Vermont Agency of Transportation
RECEIVED
CK'D BY J. Grigas / R. Foster OK'D BY G. Laroche
January 21, 2016
RESUBMIT Yes Rejected
BY K. Higgins DATE 02/08/2016

BRIDGE RAIL DETAILS SHEET

ROUTE NO. T.H. 3 (CLASS 2), RURAL COLLECTOR, BRIDGE # 11
TOWN OF CLARENDON, RUTLAND COUNTY, VT.

DRAWN	E.P.	1/20/16
CHECKED	D.L.	1/20/16
APPROVED		
SCALE	SCHEMATIC	
DRAWING NO.	FRL - CLARENDON (48)

(ITEM # 18)

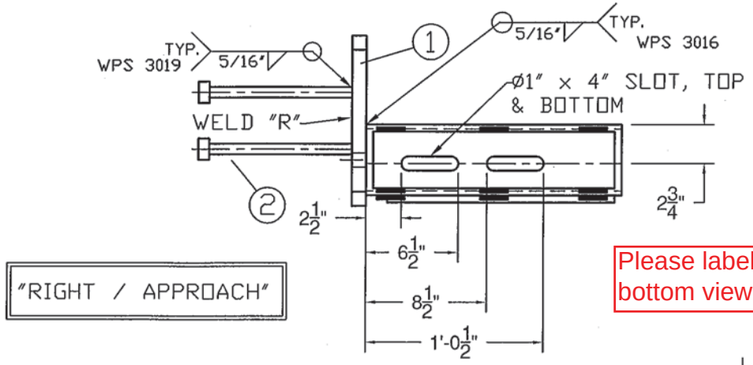
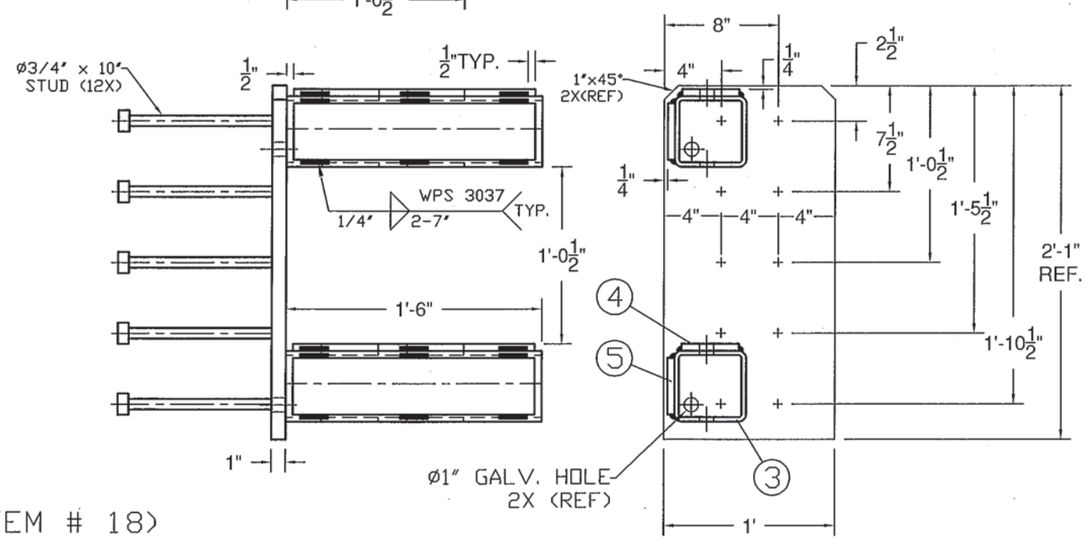
Please label top or bottom view.

(ITEM # 19)

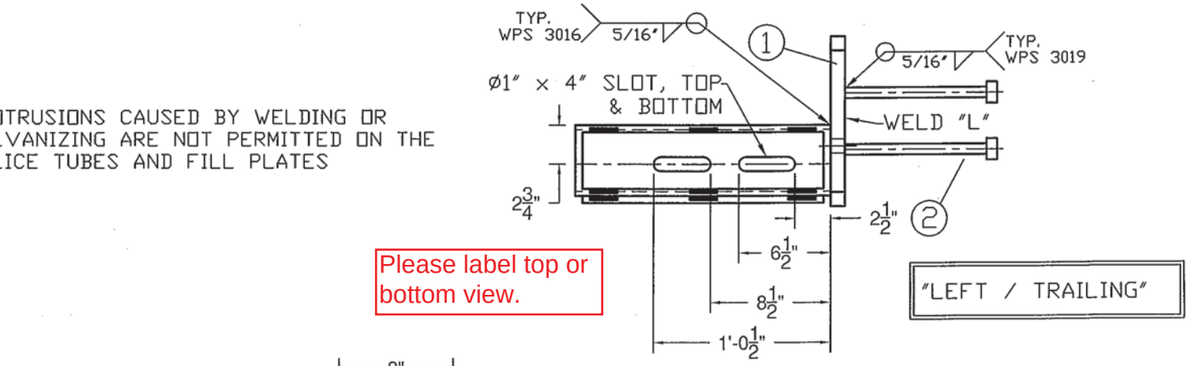
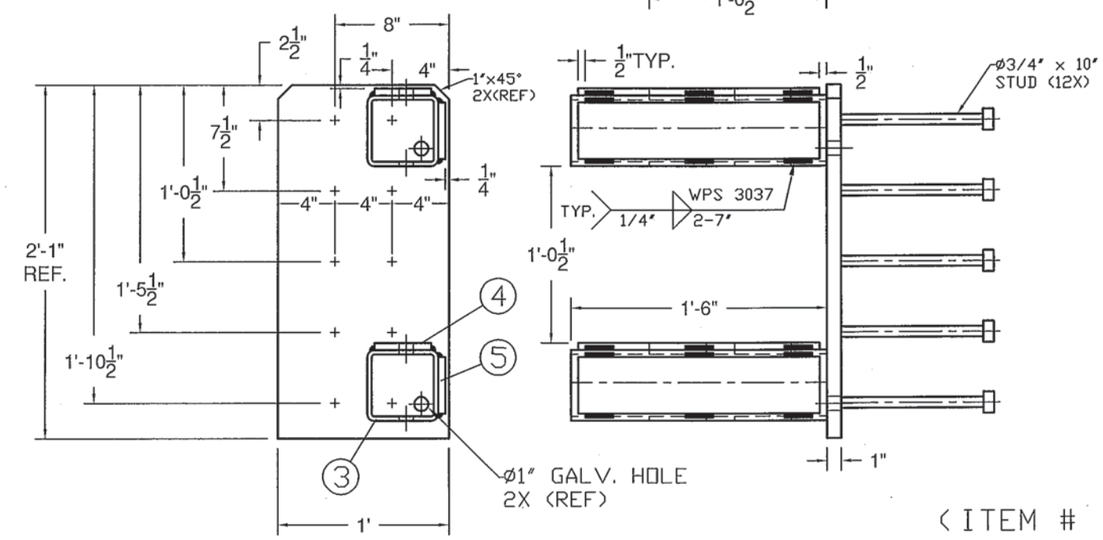
Please label top or bottom view.

Procedure No. 3006
Revision No.

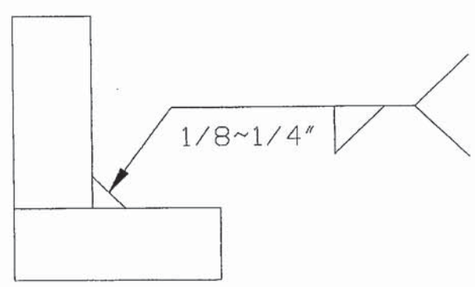
WHY DID ALL OF THESE CHANGE FOR THIS WPS? NO MENTION OF THE PQR, PROCESS IS FCAW INSTEAD OF FCAW-G, AND THE FILLER METAL SPEC CHANGED FROM 5.29 to 5.20.

Procedure No. 3012
Revision No.

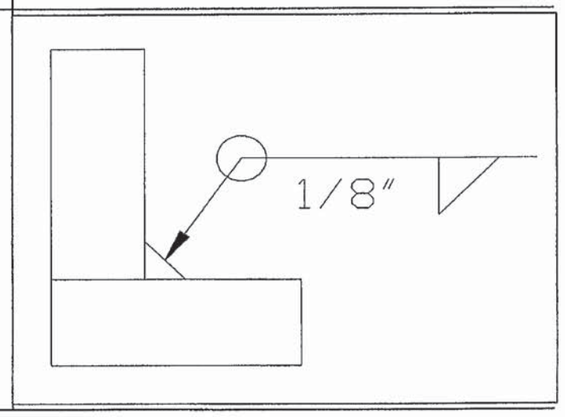
FLAT ONLY??

Procedure No. 3019
Revision No.

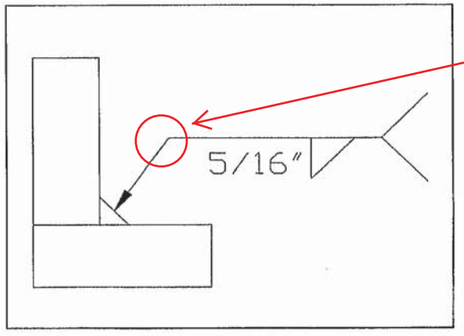
Shear Studs should be ASTM A108 and meet the requirements of subsection 714.10 of the Standard Specifications.

To be Welded all around

Procedure No. 3037
Revision No.

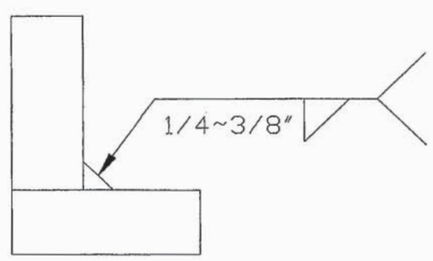
THIS DOESNT MATCH THE MATERIAL LIST
